Technical Bulletin

Model
911 C2/C4/T
944, 968

Cooling Fan Motor

Number
9305

5mm Vent

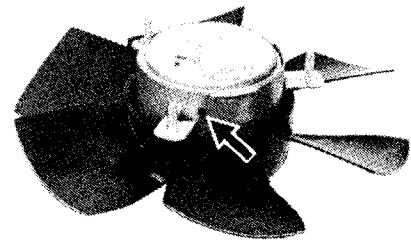
Correct positioning of the cooling fan motor for the A/C condenser and oil cooler on 6 cylinder models and radiator cooling fan on 4 cylinder cars.

When replacing or installing the cooling fan motor in any of the above mentioned vehicles, if the motor casing has a vent hole, it must point downward.
